Access Compliance Report

Public Rights-of-Way

(Curb Ramps)

Intersection ID: 10011488	Main Street: SHAMROCK_DR	Cross Street: N/A	Location: SW
ADA ID: 7DF49EEB6255	Ramp Type: Perp	Initial Pass/Fail: Fail	Overall Compliance: No
			Severity Score: 21.25

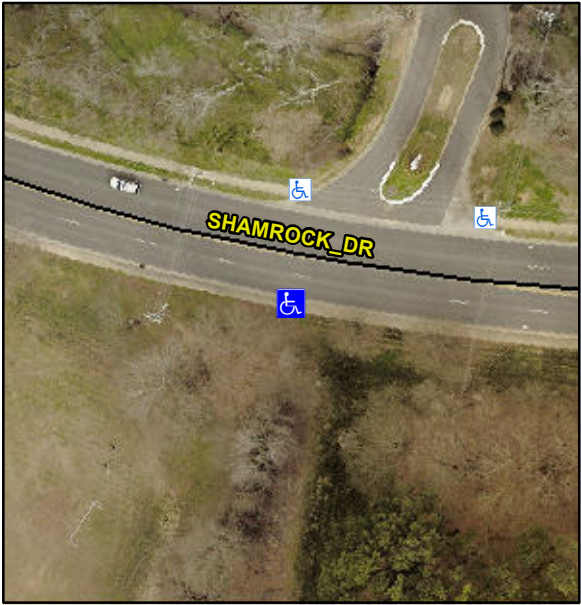
Codes/Mitigation Info/Possible Solution			Field Measurements/Component Compliance		
	Possible Solutions:		Compliance	Description	Data
	Remove & Replace Entire Ramp.		No	Ramp Length (in)	60.0
			No	Ramp Width (in)	41.0
			N/A	Flare Type LT	N/A
			N/A	Flare Slope LT (%)	N/A
			N/A	Flare Traversable LT?	No
			N/A	Landing Length (in)	N/A
			N/A	Landing Width (in)	N/A
			N/A	Landing Slope (%)	N/A
			N/A	Landing X Slope (%)	N/A
			N/A	Landing Curb? (Y/N)	N/A
			N/A	Shared Landing?	N/A
			N/A	Gutter Ponding?	N/A
			N/A	Gutter Lip Ht (in)	N/A
			N/A	Painted X Walk1?	No
				X Walk 1 Direction	To N
			N/A	X Walk 1 Width (in)	N/A
				X Walk 1 Slope (%)	0.1
				X Walk 1 X Slope (%)	1.4
			N/A	Ramp inside XWalk1?	N/A
<p>Surveyor Notes:</p> <p>N/A</p> <p>PROW/ADA:</p> <p>Not Found, R304.5.1, R304.2.2</p>			N/A	Flare Type RT	N/A
			N/A	Flare Slope RT (%)	N/A
			N/A	Flare Traversable RT?	No
			N/A	DWS Provided?	N/A
			N/A	DWS Contrast?	N/A

N/A	DWS Length (in)	N/A
			N/A	DWS Full Width?	N/A
			N/A	DWS Offset (in)	N/A
			N/A	Gutter Slope (%)	N/A
			N/A	Gutter X Slope (%)	N/A
			N/A	Painted X Walk2?	N/A
				X Walk 2 Direction	N/A
			N/A	X Walk 2 Width (in)	N/A
				X Walk 2 Slope (%)	N/A
				X Walk 2 X Slope (%)	N/A
			N/A	Ramp inside XWalk2?	N/A
			N/A	Clear Space?	N/A
			N/A	Clear Space to XWalk (in)	N/A
			N/A	Storm Grate/Utility Hazard?	N/A
				Storm Grate/Utility Type	
<p>Total Cost:</p> <p>\$ 1850.00</p>			N/A		N/A
			Yes	Surface Condition? (G/P)	Good
